Field Modification FM22007

VS2.5 (3 PS): Replacing UG69* and NAPS43* with UG132 and NAPS58A

Issue 1.107 March 2025

This document provides instructions for customers to replace the three UG69* Power Supply Modules and NAPS43* Power Supply Distribution PWB with two UG132 Power Supply Modules and NAPS58A Power Supply Distribution PWB in a VS2.5 transmitter.

Figure 1: VS2.5 Top View with NAPS43 and UG69s

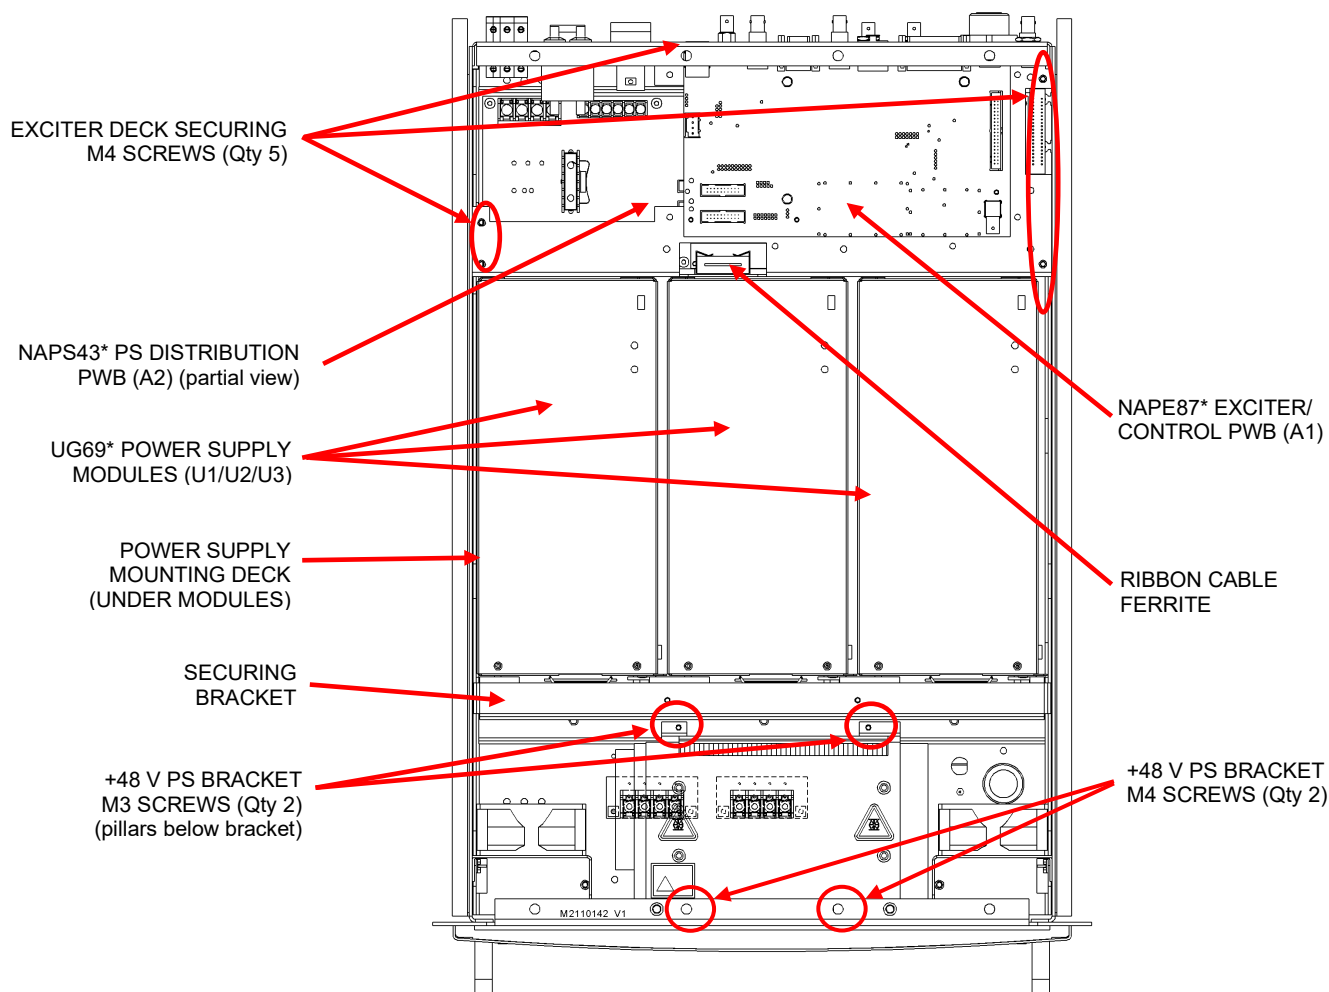
2 UG69* POWER SUPPLY MODULE/NAPS43* POWER SUPPLY DISTRIBUTION PWB REMOVAL

Refer to Figure 1 and Mechanical Drawings MD-1 and MD-4 in Section 6 of the VS2.5's Troubleshooting Manual for reference.

- (a) Remove the VS2.5's top cover and retain hardware.
- (b) Remove the securing bracket from the front of the Power Supply Modules (U1 to U3) by removing the two (2) M3 screws in the top of the bracket (see Figure 1) and the two (2) M4 countersunk screws in each side of the transmitter chassis. Discard bracket and retain hardware.
- (c) Slide the Power Supply Modules toward the front of the transmitter to disengage them from their mating connectors.
- (d) Remove the Power Supply Modules from the transmitter. If desired, retain any functional Power Supply Modules as spares for other transmitters that use UG69* modules. Discard defective Power Supply Modules as per local electronics waste management policies (if applicable).

- (f) Remove and retain the five M4 screws that secure the Exciter Deck (see Figure 1).
- (g) Before removing the Exciter Deck, ensure that the exciter wiring and associated items are clear of the Power Supply Distribution PWB and Exciter Deck, cutting tyrap if necessary. Cut the tyrap around the Ribbon Cable Ferrite (see Figure 1) to move the ribbon cables clear of the Exciter Deck and be careful in the following step not to damage the ferrite. Cut the adhesive tape that secures the Ribbon Cable Ferrite bracket to the Exciter Deck. Retain the adhesive tape for re-installation.

Figure 2: Orientation of Installed Items – Exploded View

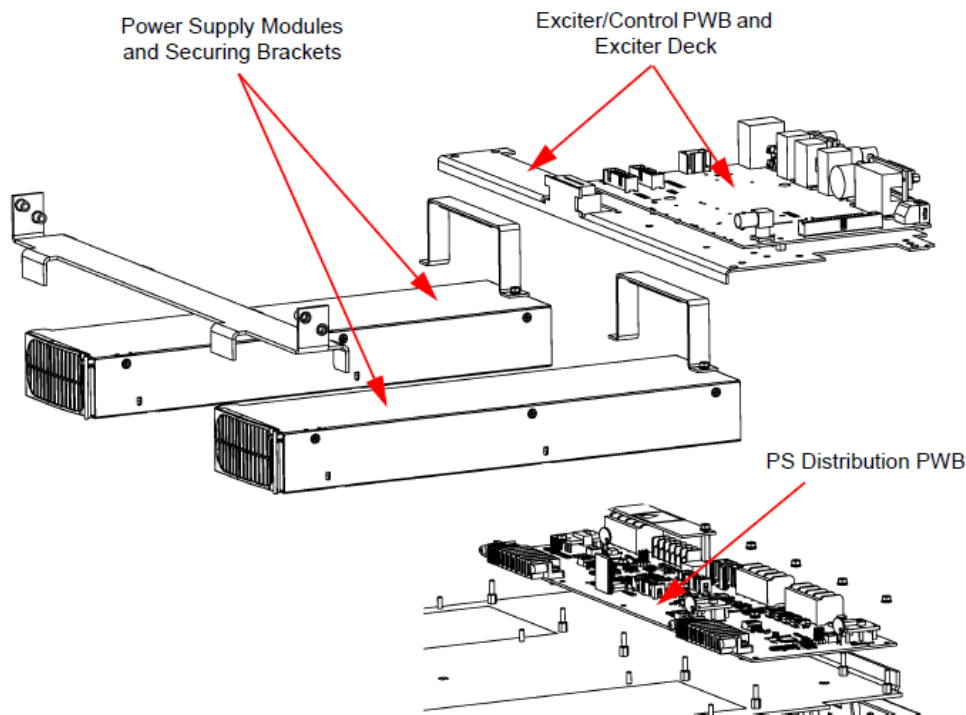
Refer to Figures 2, 3 and the attached Mechanical Drawing MD-4 for reference.

- (d) Install the Power Supply Distribution PWB on its 11 mounting pillars (see Figures 2 and 3). Use hardware retained in step 2.2 (d) to secure the PWB (not all hardware is reused), using a 5.5-mm nut driver for nine M3 nuts, split and flat washers, and a 6-mm nut driver for two pillars near TB1 and TB2.

Figure 3: New Power Supply Mounting Deck

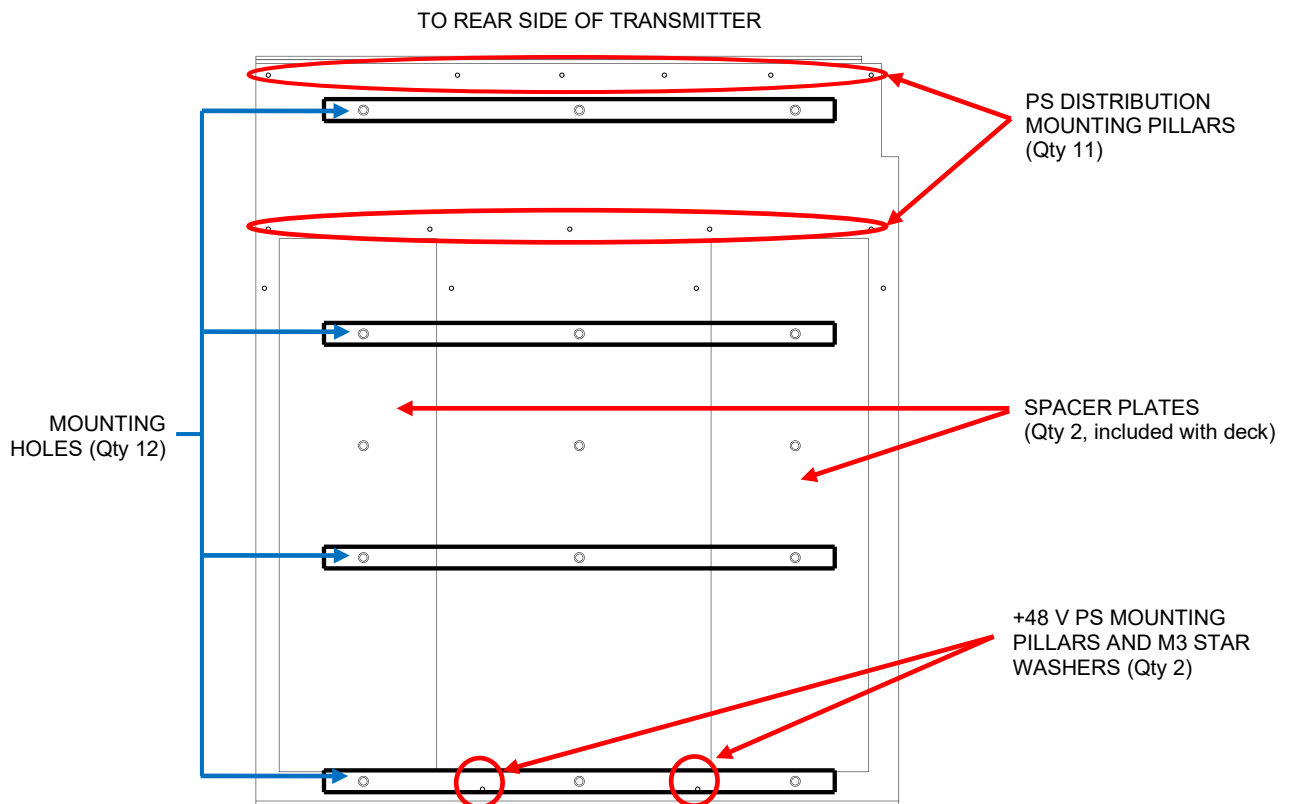
- (b) Install 11 of the 12 pillars and washers retained in step 2.2 (h) in the PS Distribution Mounting Pillars positions shown in Figure 3. Install the chafe rail on the rear side edge.

- (c) While ensuring that all wires removed in step 2.2 (c) are clear of the deck area, install the Power Supply Mounting Deck to the transmitter chassis using the 12 M3 countersunk screws retained in step 2.2 (e). See Figure 3 for mounting locations for both scenarios.

- (f) Connect the 17 wires (# 7 through 14 and 25 through 33) removed in step 2.2 (b) to terminal blocks TB1 through TB4 of the Power Supply Distribution PWB. Refer to Table 4.3, Wiring List – VS2.5 Transmitter of the Troubleshooting Manual for wiring details.
- Torque connections on TB1, TB3 and TB4 to 20 in-lbs (2.24 N-m).
 - Torque connections on TB2 to 6 in-lbs (0.67 N-m).
- (g) Re-install the cover over TB1 and TB2 using retained M3 screws.
- (h) Use a 6-mm nut driver to re-install the pillars retained in step 2.2 (g) on the Power Supply Mounting Deck, on top of new M3 star washers (Nautel Part # HMW10) from the Hardware Kit. See Figure 3 for +48 V Power Supply mounting pillar locations.

Figure 4: VS2.5 Top View with new PS Distribution PWB and Power Supply Modules

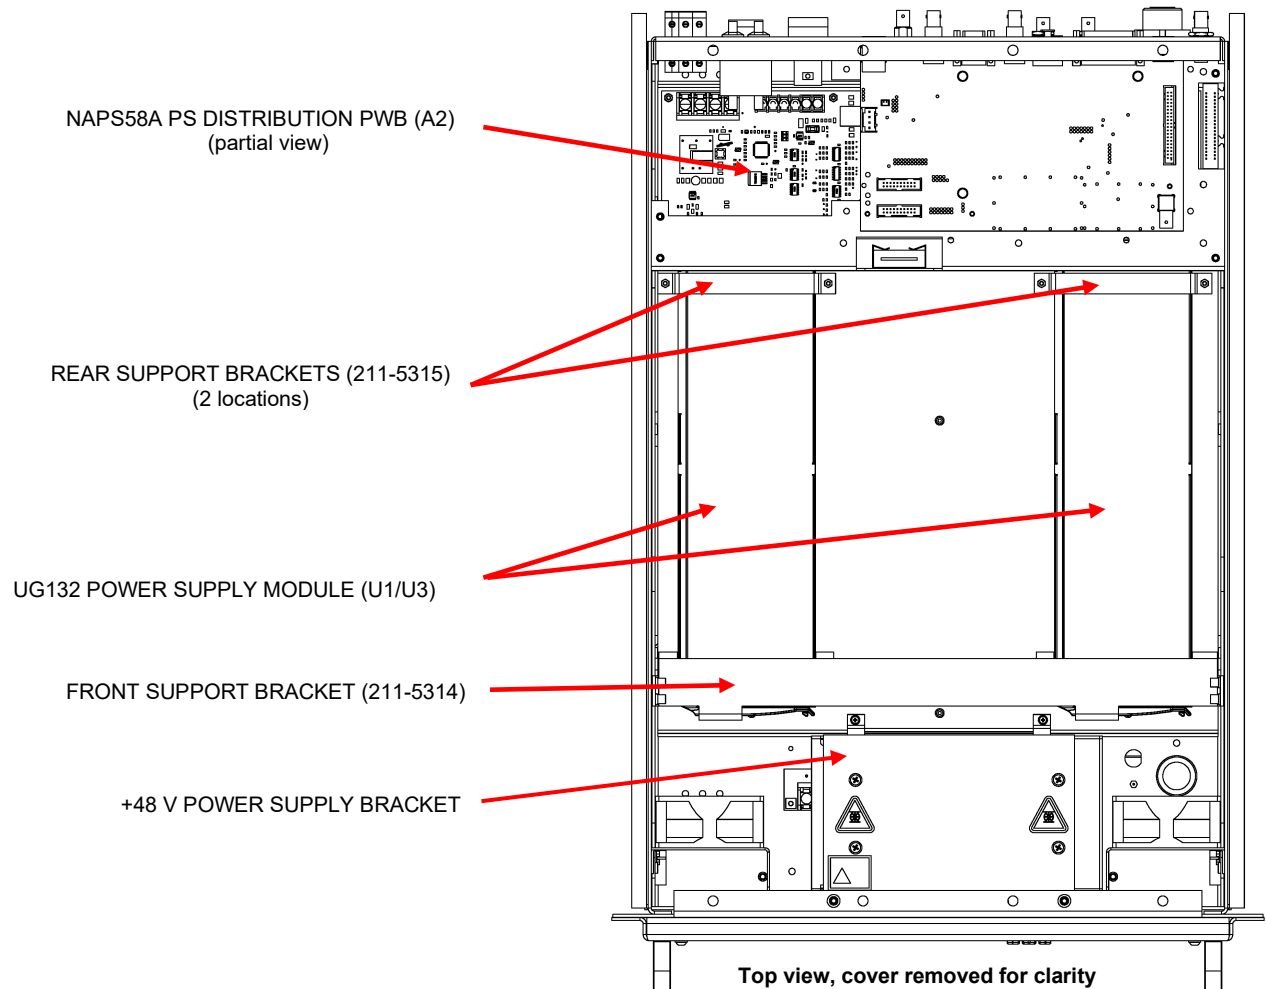
- (b) Install the new Power Supply Modules in the U1 and U3 positions of the transmitter (the middle position, U2, is no longer used) and slide them toward the rear of the transmitter to engage them with their mating connectors. The Power Supply Modules should be resting on their respective Spacer Plates (see Figure 3) when correctly positioned.
- (c) Install the Front Support Bracket on the front of the Power Supply Modules using the four M4 screws removed in Step 2.1 (b). The bracket is secured with two screws on each side of the transmitter. See Figure 4.
- (d) Install the two (2) Rear Support Brackets on the rear of the Power Supply Modules using the four (4) sets of M3 nuts and washers (Nautel Part #'s HMN02, HMW02 and HMW32), found in the Hardware Kit. See Figure 4.

- (e) Move the +48 V Power Supply Bracket and its wiring to its original position. Secure the +48 V Power Supply Bracket using the hardware [two (2) countersunk M4 screws and two (2) M3 screws] retained in step 2.2 (e). Install the M4 screws just above the front panel. Install the M3 screws on the pillars installed in step 3.1 (h).
- (f) Use provided tyrapas, as required, to secure wiring.
- (g) Install the VS2.5's top cover using hardware retained in step 2.1 (a).
- (h) Upgrade the software of the VS2.5 transmitter to VS SW 5.3.2. Refer to the VS2.5 Operations and Maintenance manual for instructions.
- (i) Obtain Information Sheet IS22001 and follow the procedure to initiate an exciter attenuation routine.
- (j) The modification is complete. Return the transmitter to proper operation.

Figure SD-5A

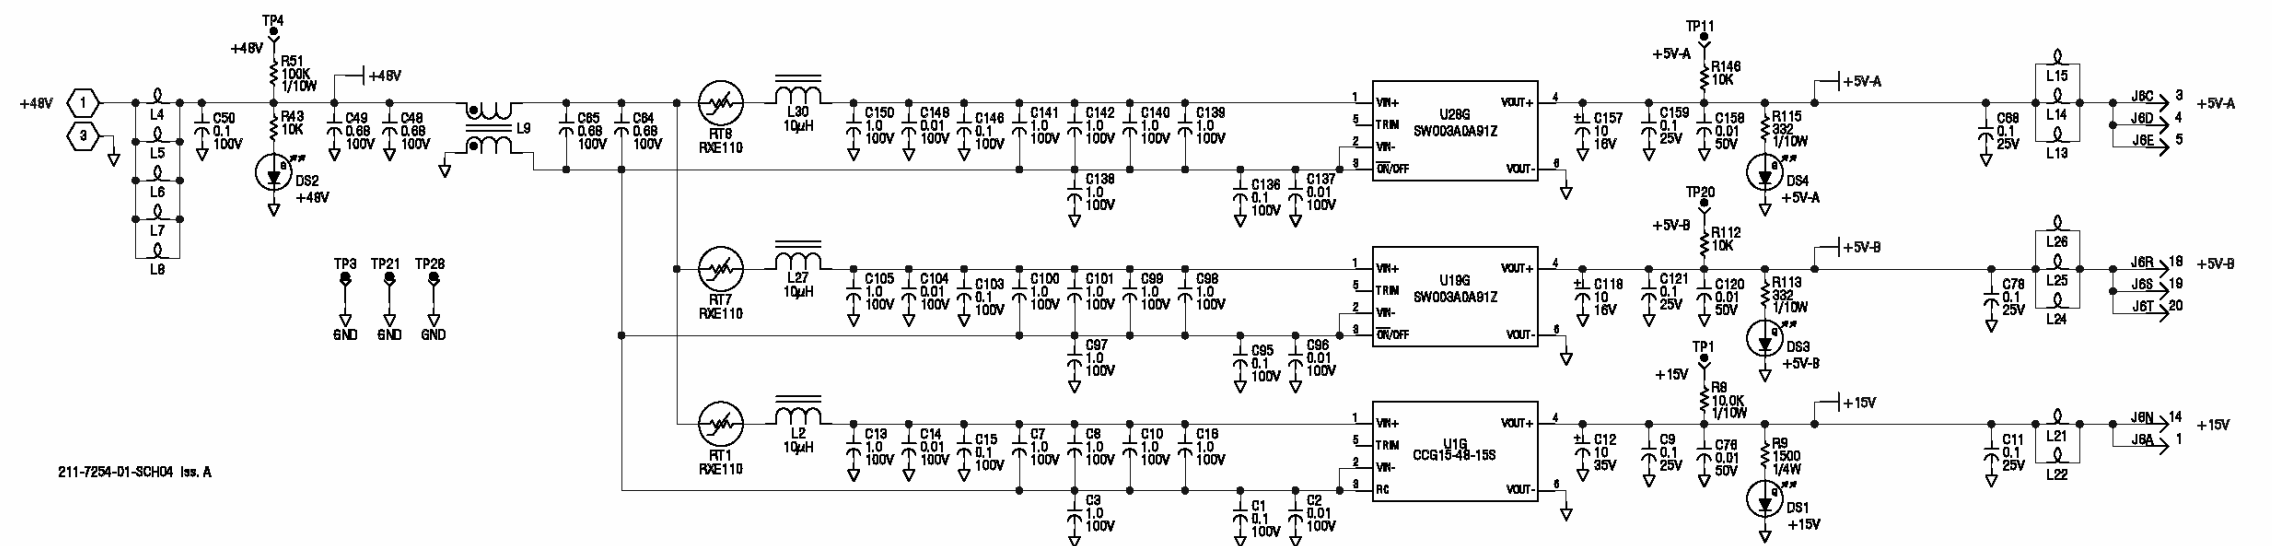
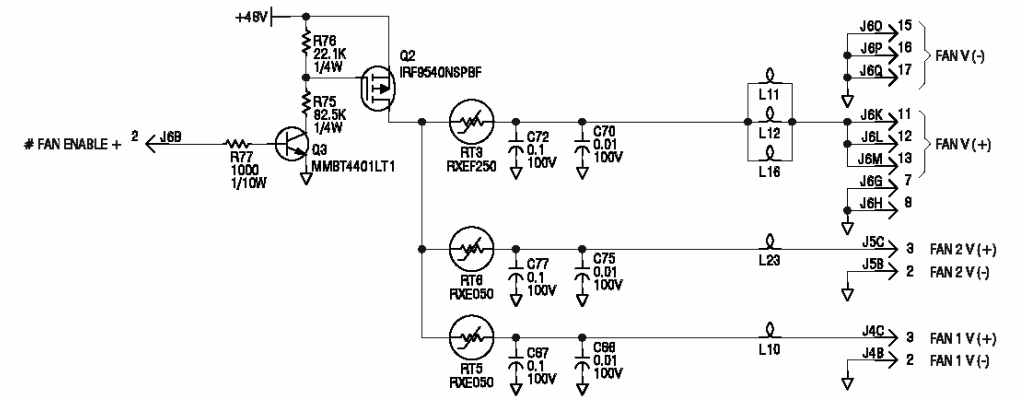
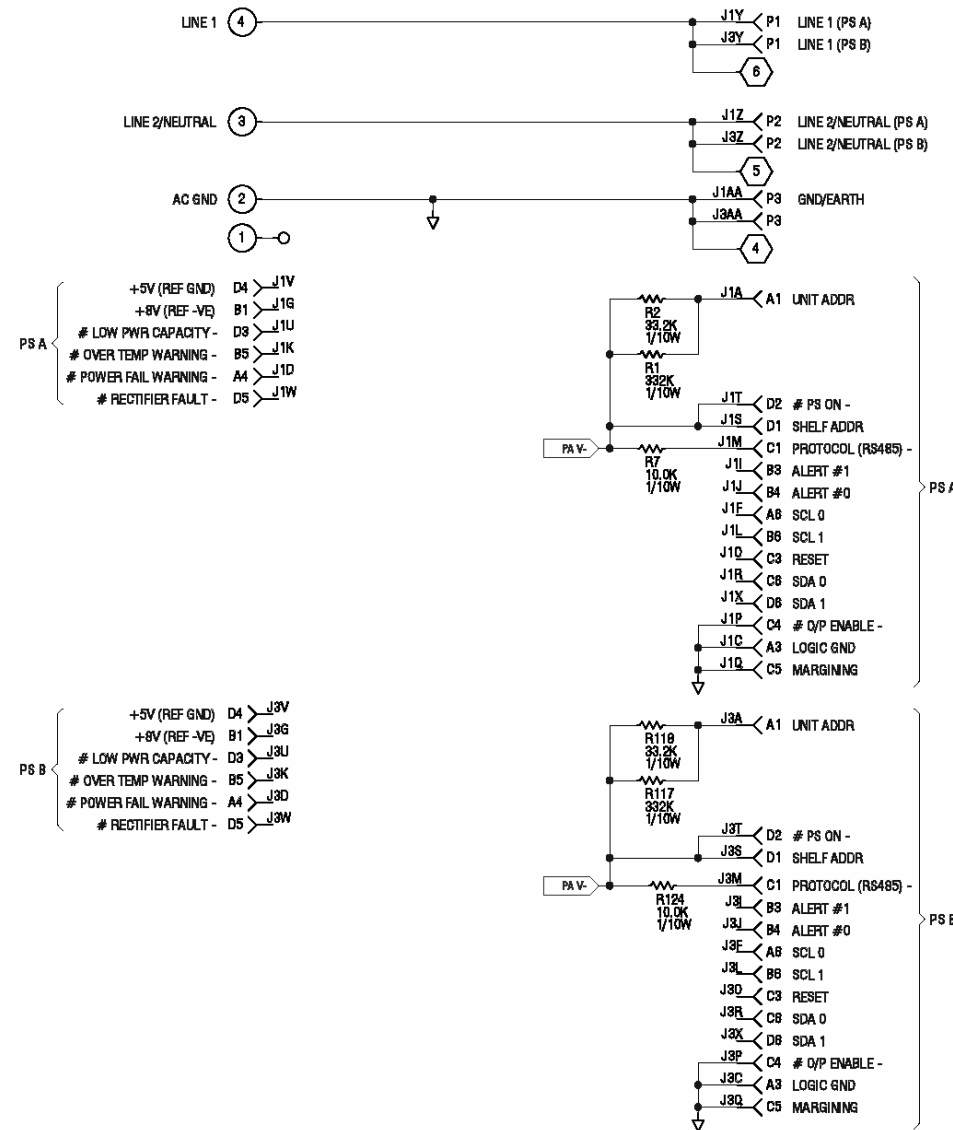
- Section 5 – Electrical Schematics:
 - In Table 5-1, the NAPS43* references for SD-4 and SD-5 change to NAPS58A.
 - Electrical schematic SD-1: note that Power Supply Module U2 is not used.
 - Electrical Schematics SD-4 and SD-5 change to the schematics (SD-4, SD-5, SD-5A and SD-5B) attached to this document.
- Section 6 – Mechanical Drawings:
 - In Table 6-1, the NAPS43A and /01 reference for MD-4 changes to NAPS58A.
 - Mechanical Drawing MD-4 changes to the MD-4 drawing attached to this document.
